UNITED STATES PATENT AND TRADEMARK OFFICE

APPLICATION NO.	FILING DATE	FIRST NAMED INVENTOR	ATTORNEY DOCKET NO.	CONFIRMATION NO.
10/073,826	02/11/2002	Robert J. Medoff	U 013871-4	5504

Office Action Summary	Application No. 10/073,826	Applicant(s) MEDOFF, ROBERT J.	
	Examiner Eduardo C. Robert	Art Unit 3732

DETAILED ACTION

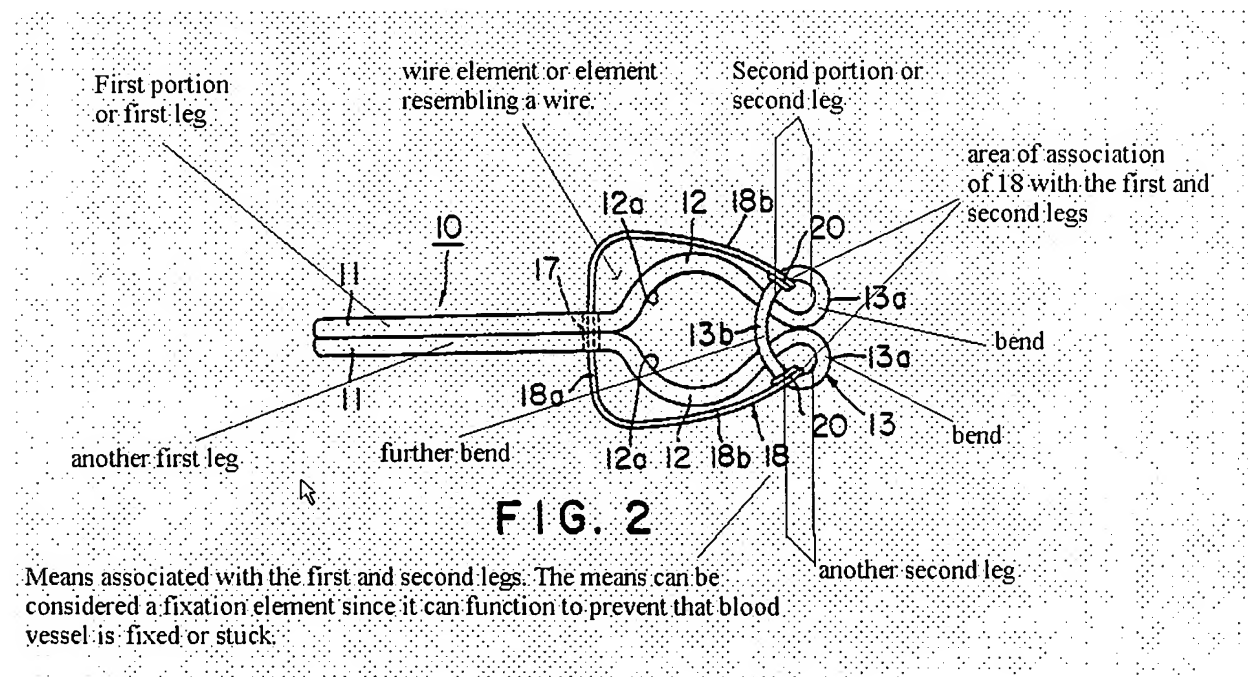
Claims 1, 37-39, 42, 48, 50, and 56 are rejected under 35 U.S.C. 102(b) as being anticipated by Segawa et al. (U.S. Patent No. 5,312,426).

Segawa et al. disclose an apparatus comprising a first portion or first leg, a second portion or second leg integrally formed with the first portion or leg by a bend, and a means 18 associated with the second leg (see Figure 2 below). It noted that the means 18 can be considered as a fixation element since it can function to prevent that a blood vessel is fixed or stuck.

The apparatus can be considered a wire element since it resembles a wire that has been twisted. Actually, as shown above, the wire element has two first portions or legs and two second portions or legs, each being joined by respective bends and the two second portions or legs are connected together by a further bend which lies in a plane with the second legs. The first and second legs have different cross-sectional areas and diameters (see Figure 3). The second legs are spaced from one another (see Figure 2 above). The first legs extend beyond the second legs (see Figure 2 above). With regard to the functional language recited in the claims, e.g. "adapted to ...", etc., it is noted that the manner in which a device is intended to be employed does not differentiate the claimed apparatus from prior art apparatus satisfying the claimed structural limitations. Ex parte Masham, 2 USPQ2d 1647 (1987). Furthermore, it has been held that the recitation that an element is "adapted to" perform a function is not a positive limitation but only requires the ability to so perform. It does not constitute a limitation in any patentable sense. In re Hutchison, 69 USPQ 138. In the instant case the apparatus of Segawa et al. has the ability to perform the function recited in the claims if one so desire.

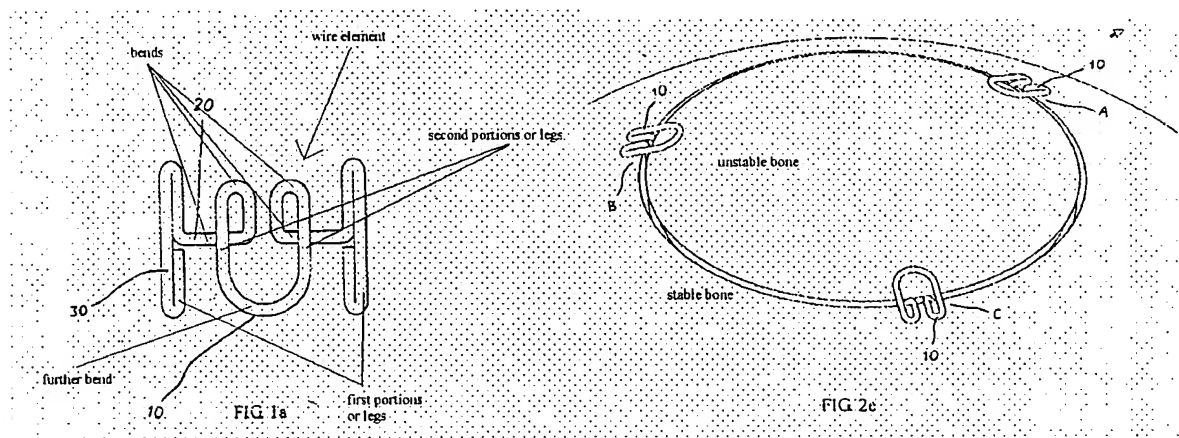
Claims 1, 37-39, 40, 42, and 48 are rejected under 35 U.S.C. 103(a) as being unpatentable over Lee (U.S. Patent No. 6,554,835) in view of Medoff (U.S. Patent No. 5,709,682).

Lee discloses an apparatus comprising a wire element or element resembling a wire, the element includes first portions or legs, second portions or legs, bends connecting the first portions with the second portions, and a further bend connecting the second portions or legs (see Figure 1a below). The apparatus is used to attached an unstable bone to stable bone (see Figure 2e below). The first and second portions of the apparatus of Lee have the ability to perform the function recited in the claims if one so desire.

Lee discloses the claimed invention except for the apparatus having a washer and bone screw. Medoff discloses an apparatus having first portions or legs and second portions or legs, and a washer, e.g. 96, engageable with the second portion legs and a bone screw, e.g. 94. The washer and bone screw secured the apparatus to a stable bone. It would have been obvious to one skill in the art at the time the invention was made to construct the apparatus of Lee including a washer and bone screw in view of Medoff, in order to secure more the apparatus to a stable bone, thus insuring that the unstable bone portion does not move.
